NUCLEAR REGULATORY COMMISSION'S  
DRAFT REQUEST FOR ADDITIONAL INFORMATION  
BY THE OFFICE OF NUCLEAR REACTOR REGULATION ON  
TOPICAL REPORT PWROG-18068-NP, REVISION 1,  
"USE OF DIRECT FRACTURE TOUGHNESS FOR EVALUATION OF RPV INTEGRITY,"  
FOR THE PRESSURIZED WATER REACTOR OWNERS GROUP  
PROJECT NO. 99902037; EPID: L-2021-TOP-0027

As a result of the review of TR PWROG -18068, Rev. 1, the NRC staff has determined that the request for additional information (RAI) questions provided below are needed to complete the next phase of the review.

Figure 6: Relationship of Embrittlement Shift between  $\Delta T_{30}$  and  $\Delta T_0$  [for Welds](#)  
 ([Reproduction of Figure 32 of \[43\]](#))

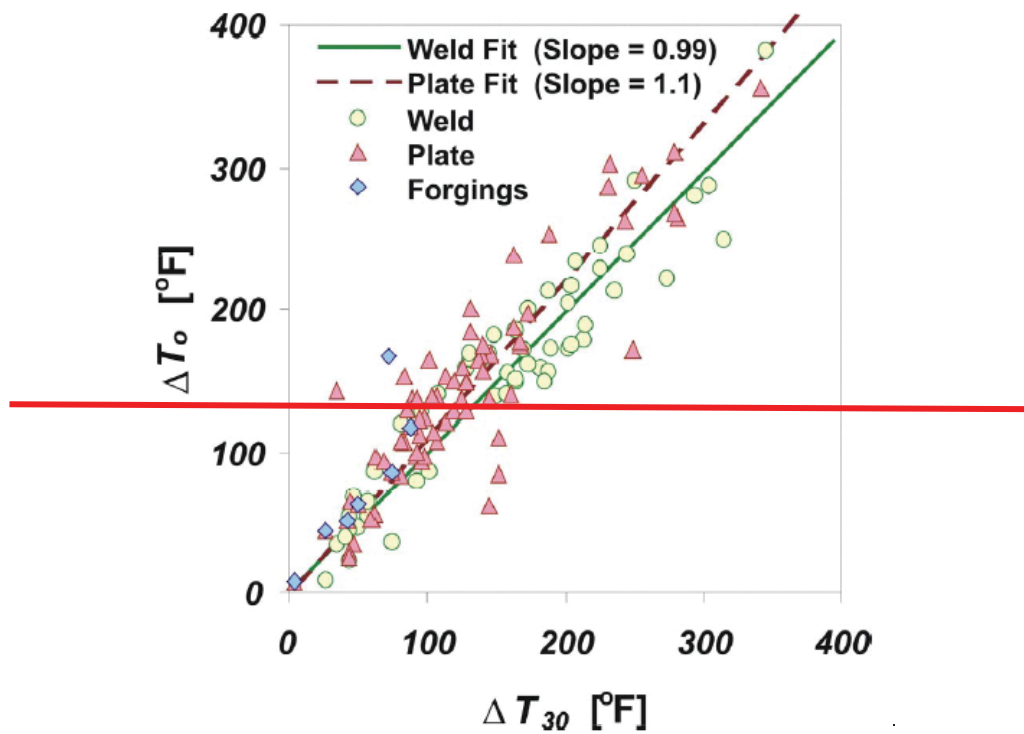
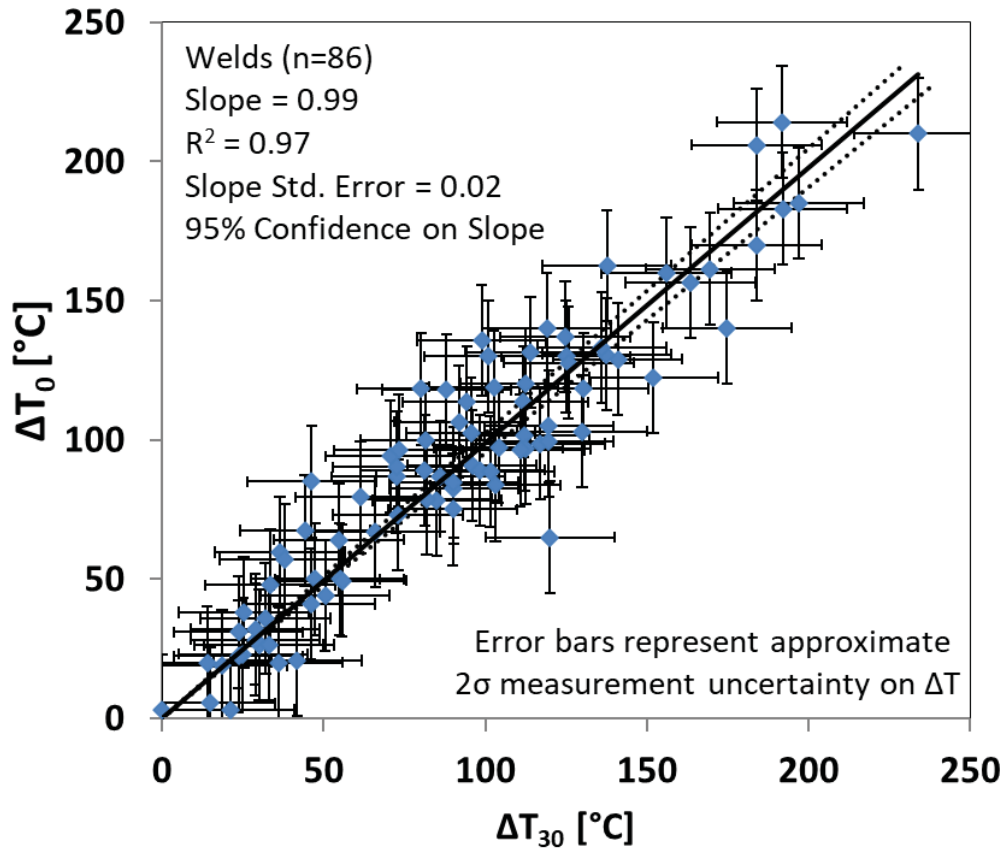
The NRC staff noted that the discussion of the correlation between  $\Delta T_{30}$  and  $\Delta T_0$  (shown in Figure 6 of the TR) does not include model uncertainty (i.e., uncertainty in the correlation). Regardless of the basis as used in NUREG-1807, “Probabilistic Fracture Mechanics – Models, Parameters, and Uncertainty Treatment Used in FAVOR Version 04.1”, the NRC staff is not clear that this precedent should apply in the methodology as used in the TR. Therefore, some basis for not considering model uncertainty should be provided. For a given  $\Delta T_0$ , the NRC staff noted that the spread in observed  $\Delta T_{30}$  values can easily be greater than 100°F. Thus, there are

Provide additional justification to support the proposed use and treatment of the model uncertainty in the correlation between  $\Delta T_{30}$  and  $\Delta T_0$  as applied in the methodology in the TR. This justification should:

In some cases, there is a measured difference between the embrittlement shift in  $\Delta T_{30}$  and  $\Delta T_0$ . Since the ETC model used is based on  $\Delta T_{30}$ , this difference ~~should be~~ is taken into account. There is no industry accepted ETC model based on  $\Delta T_0$ . Figure 6 and Figure 7 show a number of shift measurements comparing ~~the two shifts [43]~~  $\Delta T_0$  and  $\Delta T_{30}$  for welds and base metals, respectively. The linear fit parameters and statistics for the welds, plates and forgings are shown in Table 2. The statistics show that the plate and forging fits are indistinguishable and are therefore combined as base metal. On average, the ~~ratio-slope~~ of  $\Delta T_0$  to  $\Delta T_{30}$  shift-difference for welds is 0.99 and ~~1.1~~ 1.08 for ~~plates~~ base metals. The linear fit statistics are excellent with a low standard error on the slope and a high  $R^2$ , meaning the slope is known with a high confidence level. For simplicity and conservatism, 1.0 is used for welds and 1.1 is used for base metal in several equations. The addition of the 0.01 or 0.02 conservatism in the slope is more conservative than adding the slope standard error of ~0.03 into the margin term of Equation 11 where it would be combined with all the other uncertainties reducing its effect.

There is significant scatter in the individual measurements with a standard deviation of the errors of the measurement relative to the fit (residual) averaging 17°C (30°F). Each  $\Delta T_0$  and  $\Delta T_{30}$  measurement is comprised of an uncertainty of both the unirradiated and irradiated measurements with the typical combined measurement standard deviation using 2 times the square root of the sum of the squares (SRSS) is shown as error bars in Figure 6 and Figure 7 of 20°C (36°F) for both  $\Delta T_0$  and  $\Delta T_{30}$ . If the independent shift measurement uncertainties (10°C for  $\Delta T_0$  and 10°C for  $\Delta T_{30}$ ) are combined using the SRSS, the resulting 14°C (26°F)

**Figure 7: Relationship of Embrittlement Shift between  $\Delta T_{30}$  and  $\Delta T_0$  for Base Metals**

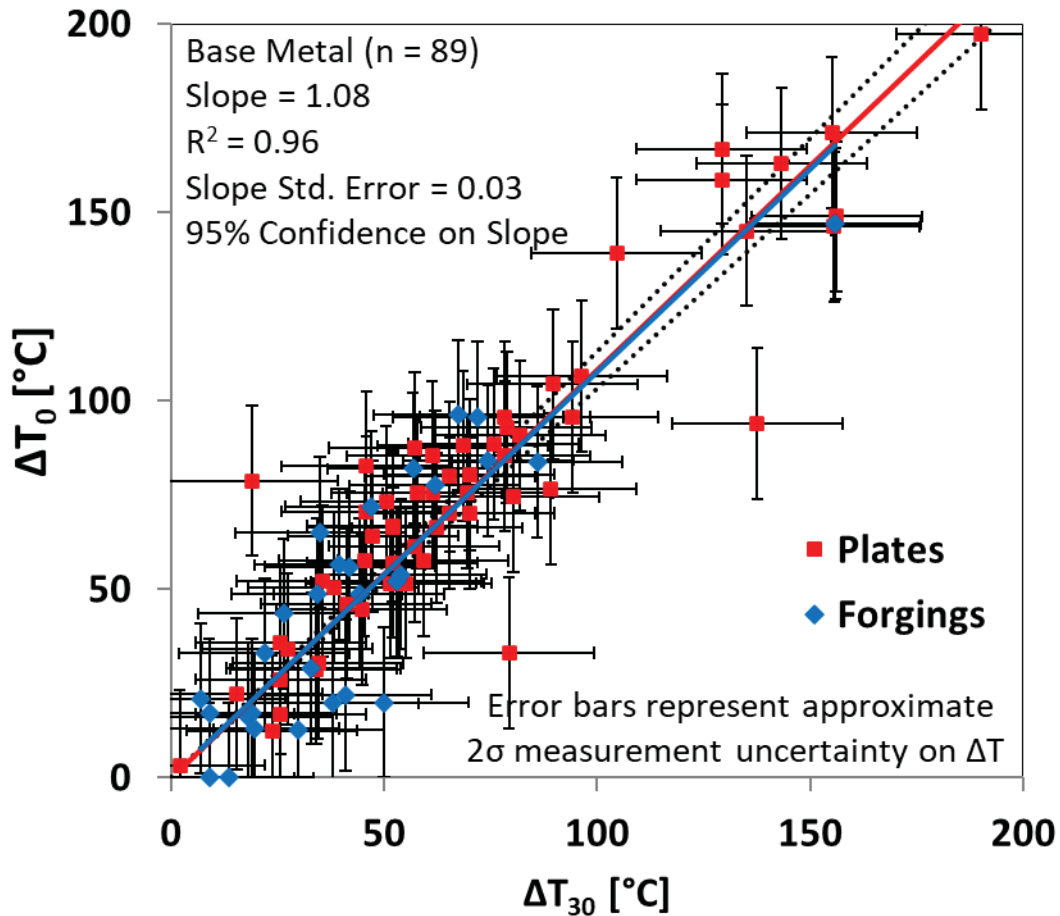
- b. Address differences between the data in Figure 6, which use unirradiated data as the reference state and the intended use of this correlation in the TR, which principally uses irradiated data as the reference state.

The TR methodology allows for adjustment of both unirradiated and irradiated  $T_0$  measurements. Unirradiated measurements use the same reference state and therefore there is no difference. For the adjustment of irradiated  $T_0$  values, in most cases the adjustments are small and any deviation in the slope due to the different (irradiated) reference state would have a minimal impact on the adjustment. The  $\Delta T_0/\Delta T_{30}$  slope is the same with the reference state for both unirradiated vs. irradiated measurements, as discussed below. There is no change in failure mechanism, only a shift in the ductile-to-brittle transition curve due to irradiation. Both the ASTM E23 Charpy impact specimens tested in the ductile-brittle transition temperature (DBTT) region (and fit with tanh to determine the reference temperature at 30 ft-lbs) and the ASTM E1921  $T_0$  reference temperature are both measuring the location of the DBTT. A cleavage event initiates in both the Charpy test as well as the E1921 fracture test after a plastic zone is formed at the notch or precrack tip. The absolute value of the two DBTT measurements is different, however the change (shift) due to neutron irradiation is caused by the same mechanism

### **4.6 APPLICATION PROCESS**

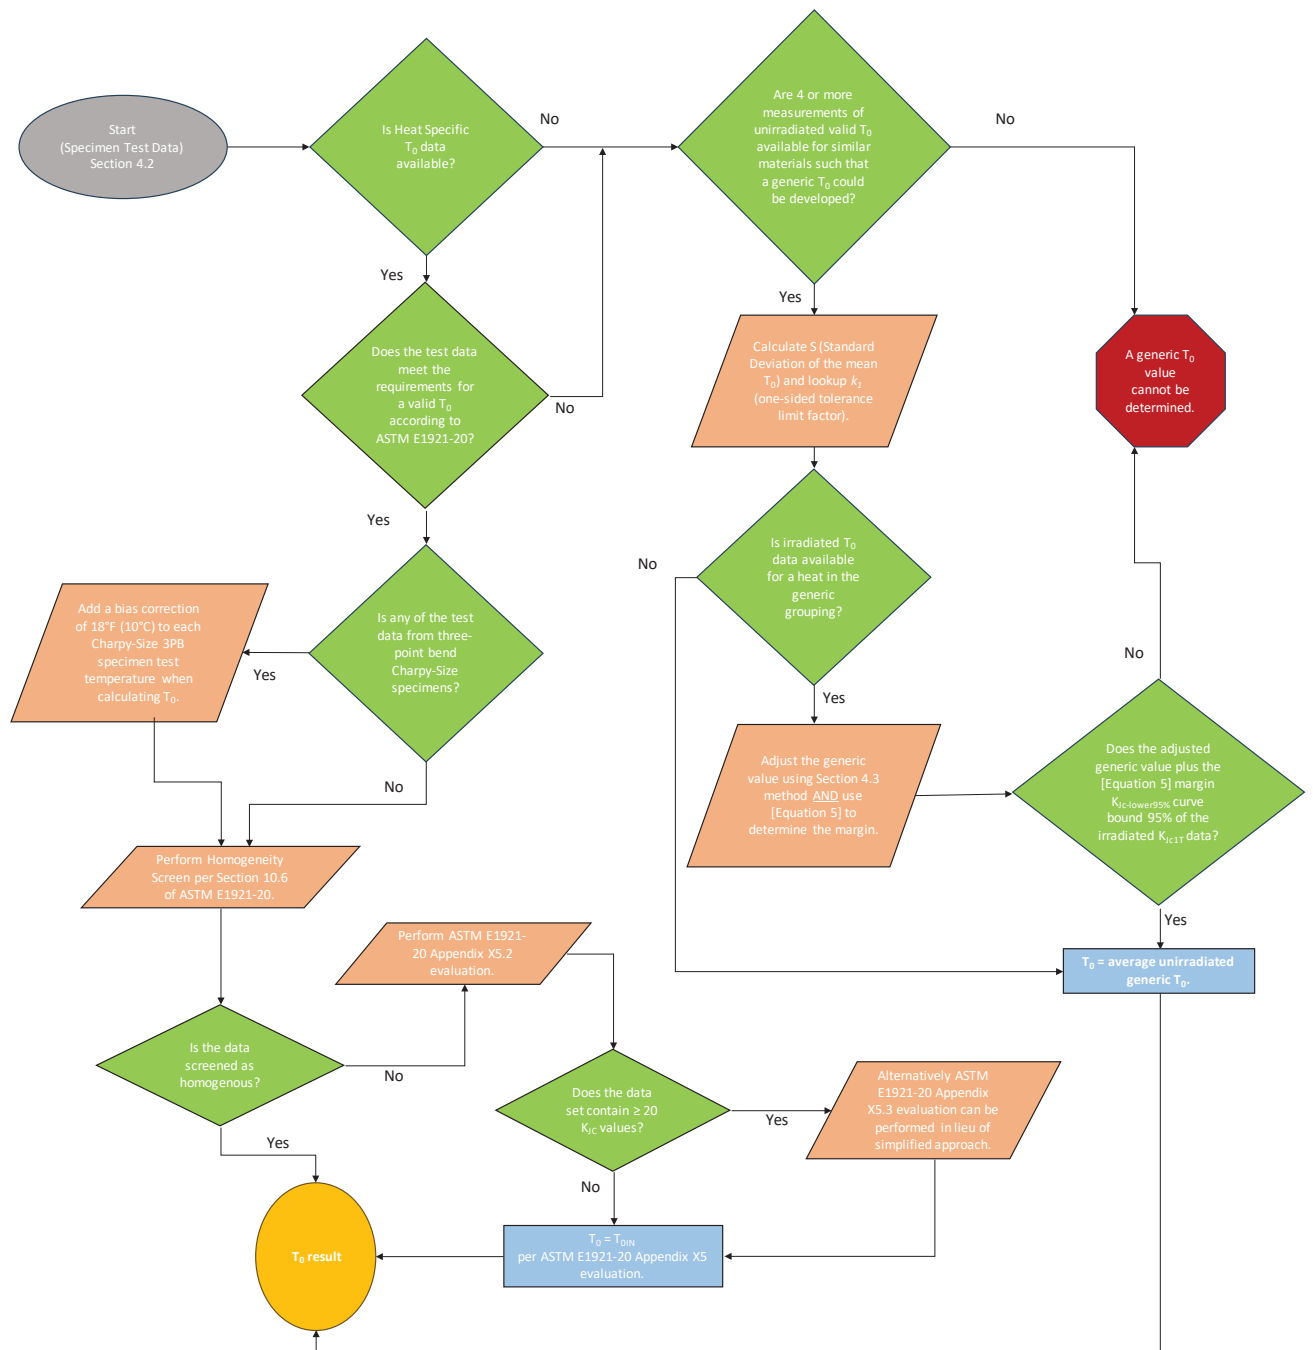
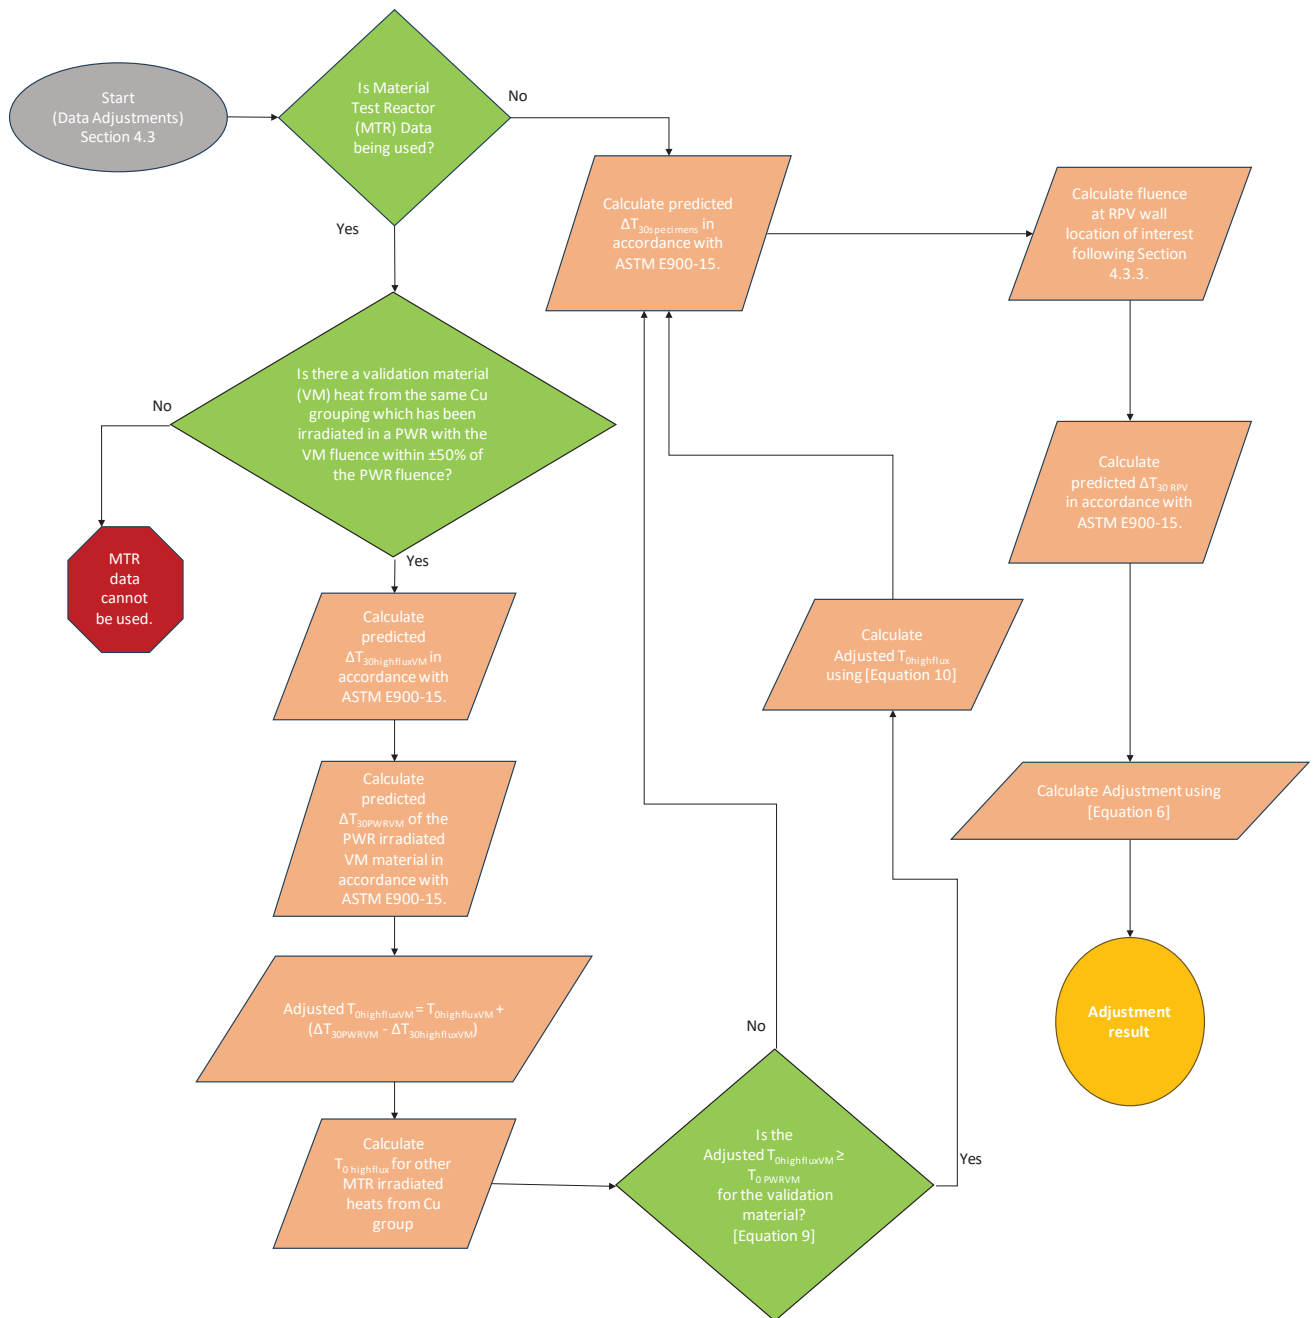
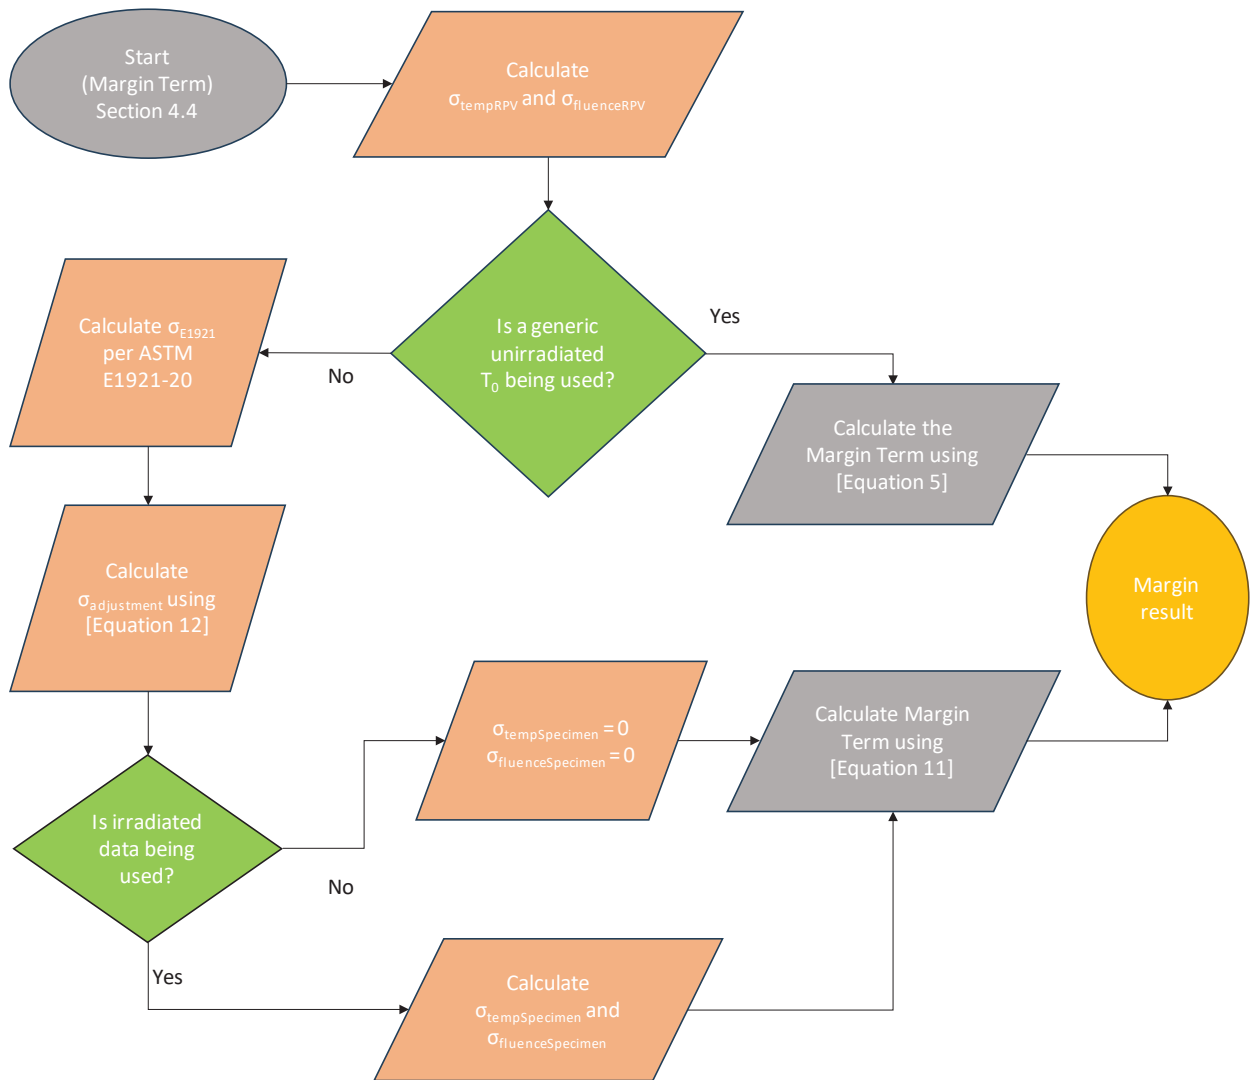
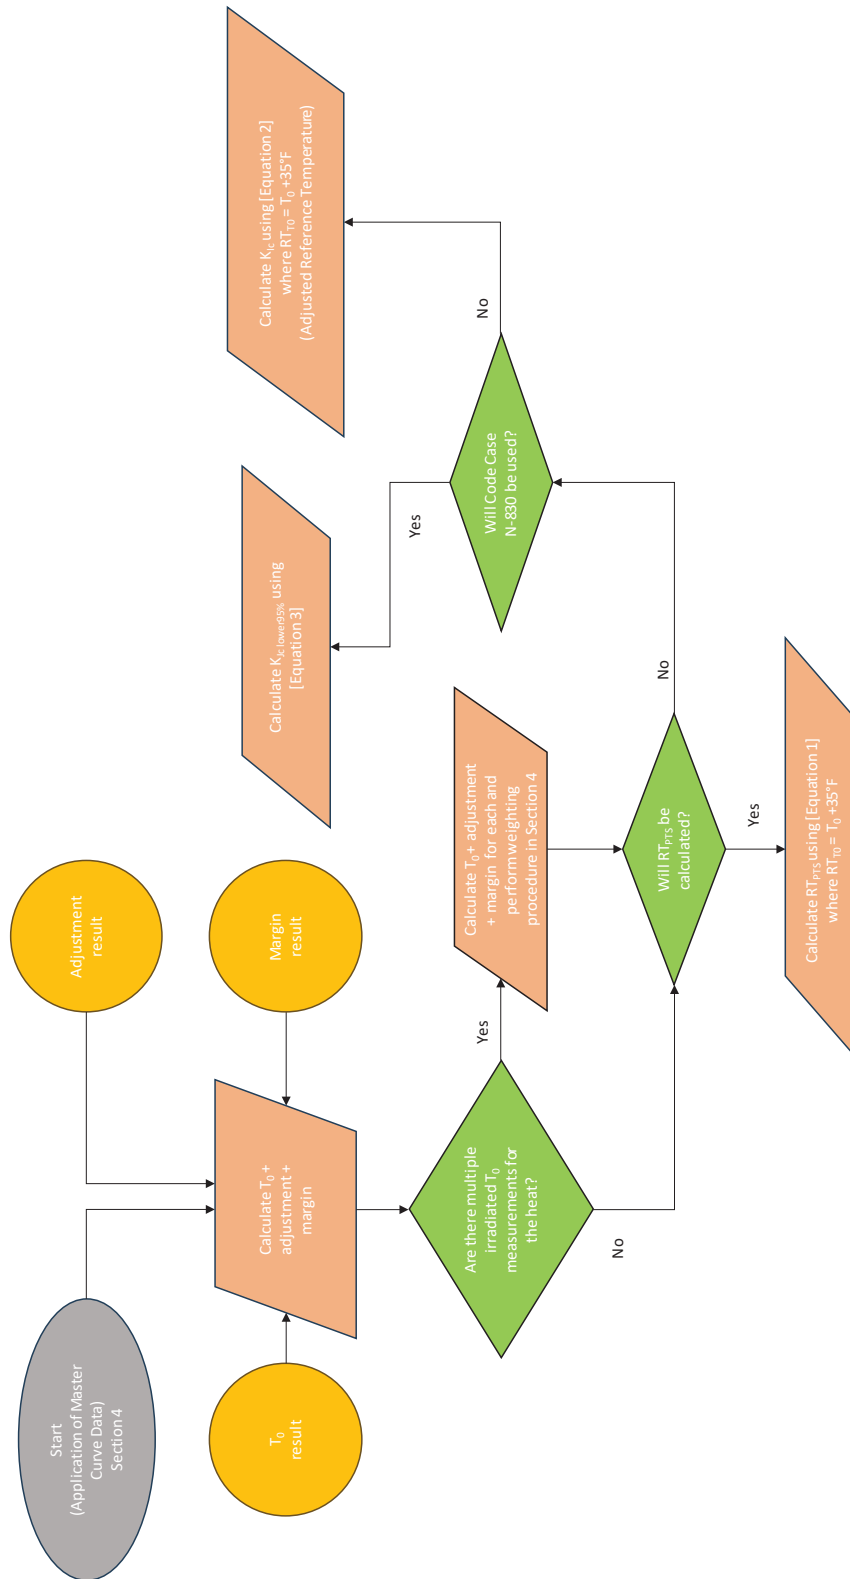
Provide a detailed description of the process by which the final calculated irradiated  $T_0$  value (with adjustment and margin as specified in the TR) is determined starting from a data set or multiple data sets of  $T_0$  values (irradiated and/or unirradiated).

The following process flow chart can be used for guidance in determining the inputs to Equations 1 through 3. For details, see the referenced Equations and Sections.

**Table C-9 Calculation of  $T_0$  per ASTM E1921-20 for the Midland Unit 1 Beltline Weld Ford MTR Irradiation**

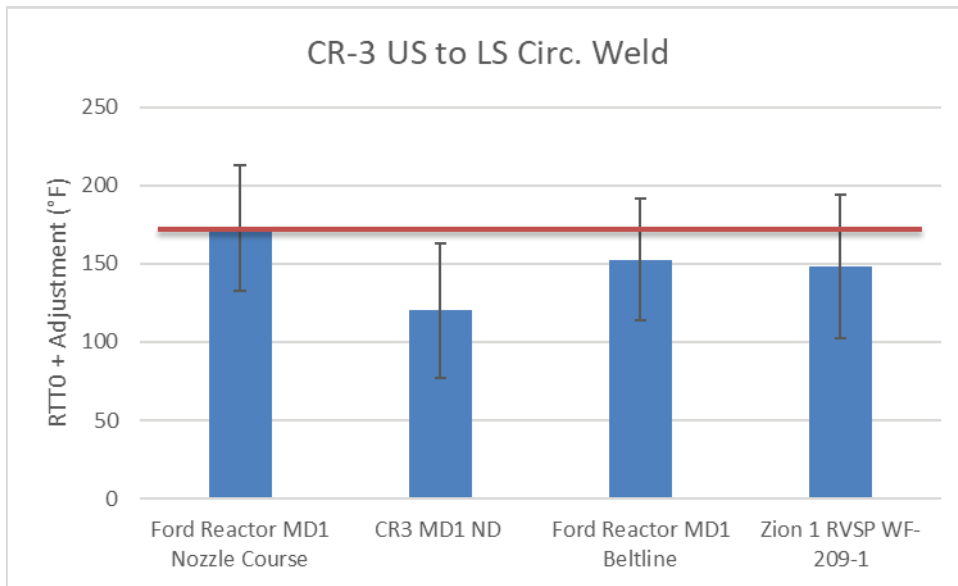
- b. Provide a description of how each  $\sigma_{\text{test}}$  value in Table C-9 was determined for each individual data set. The section(s) in the TR providing the basis for each selection should be referenced, as appropriate.

$\sigma_{E1921}$  is a function of r (the number of uncensored data per ASTM E1921-20) as shown in Table 2 in the revised TR (Table 3 in the original TR), which uses ASTM E1921-20 paragraph 10.9.

Table C-9 shows the revised TR Table C-9 to show how the various values are calculated including “N, r” and “ $T_0$  Basis”. The values have been determined using the revision to the TR methodology discussed in the response to RAI 10.a above, where the Charpy bias is added to
